TVA-BFN-TS-418

**BROWNS FERRY NUCLEAR PLANT (BFN) - UNITS 2 AND 3 -  
TECHNICAL SPECIFICATIONS (TS) CHANGE TS-418 - EXTENDED  
POWER UPRATE (EPU) - RESPONSE TO ROUND 14 REQUEST FOR  
ADDITIONAL INFORMATION (RAI) - SBWB-85 (TAC NOS. MC5263 AND  
MC5264)**

RESPONSE TO ROUND 14 REQUEST FOR ADDITIONAL INFORMATION  
SBWB-85

Figure A.1 Liquid Mass in the Core Average Nodes  
0.05 FT2/PD SF-BATT MID 102P/105F EPU

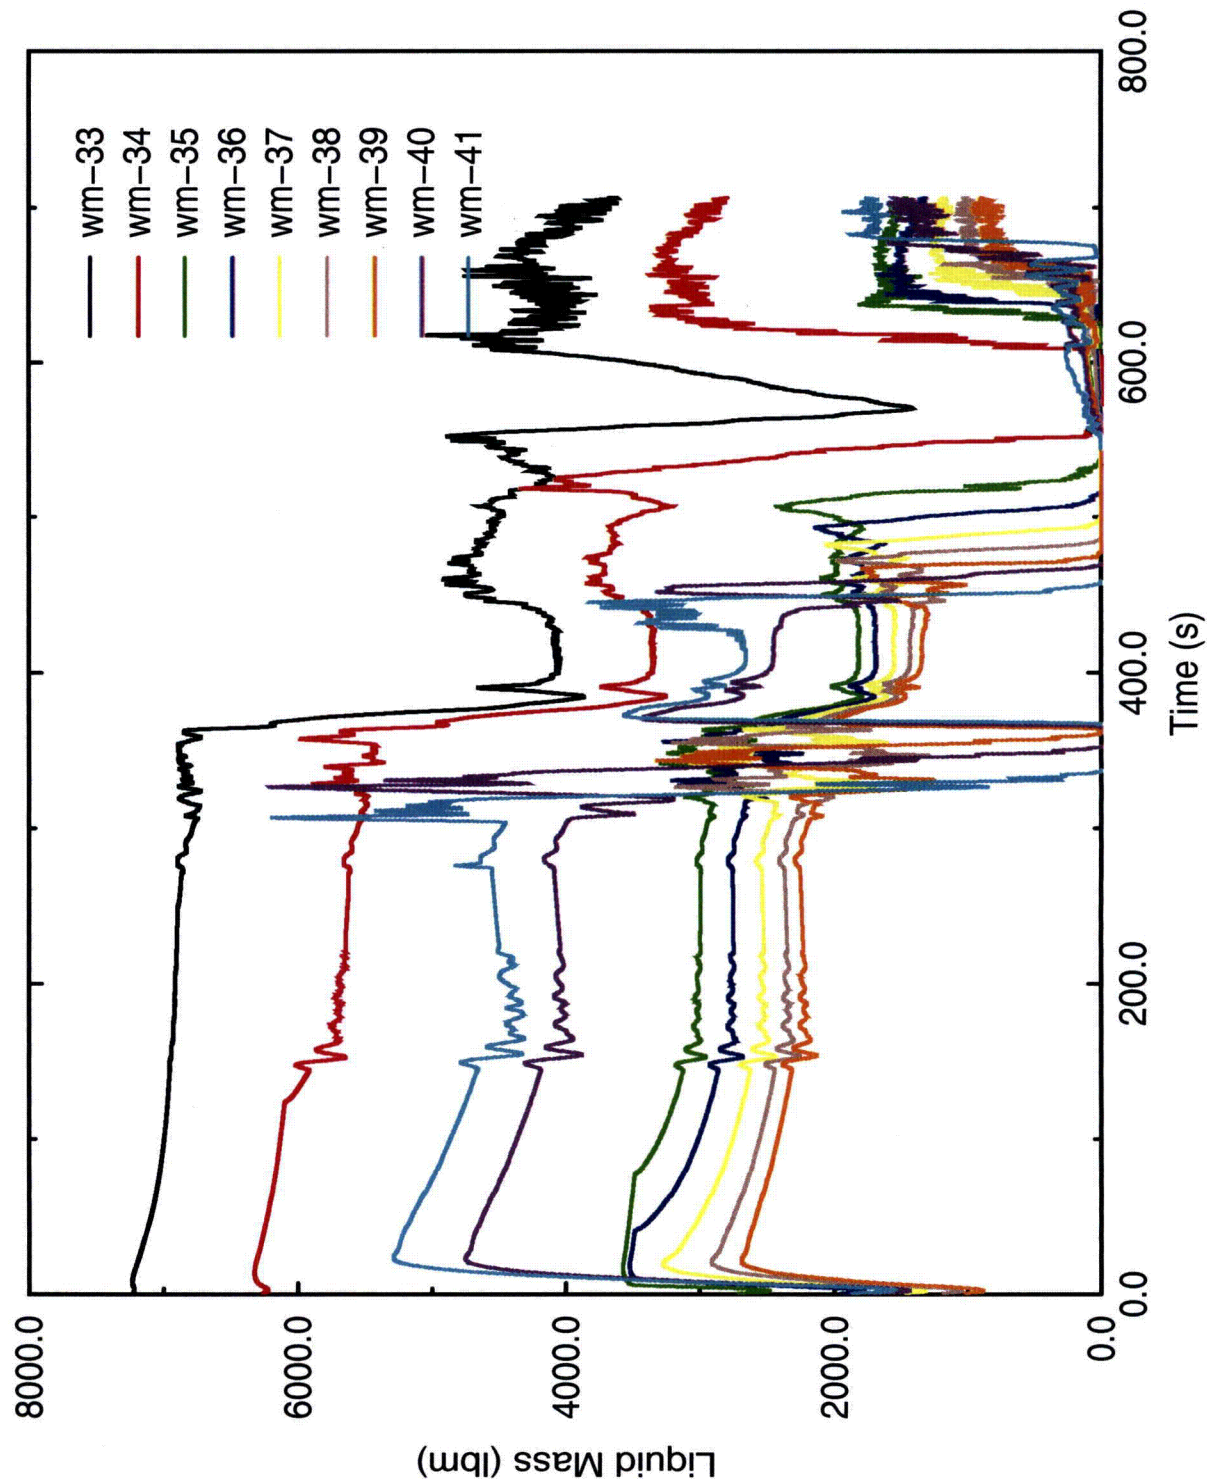
With regards to the AREVA fuel, provide the hot bundle and core average two-phase (or mixture) levels versus time for the 0.05 ft<sup>2</sup> break. Also for this break, please provide the liquid mass or liquid levels versus time in the average core and hot bundle.

The requested level data is not available since the core volumes are modeled as homogeneous nodes. However, in response to the NRC request, the liquid mass in each of the core average and hot bundle nodes for both mid- and top-peaked 0.05 ft<sup>2</sup>/PD breaks is provided in Figures A.1 through A.4. These figures illustrate the liquid water distribution in the average core and hot channel calculations, similar to the information that a mixture level would provide if it were calculated. The requested total liquid mass versus time data is also provided in the files on the compact disk provided in Enclosure 2.
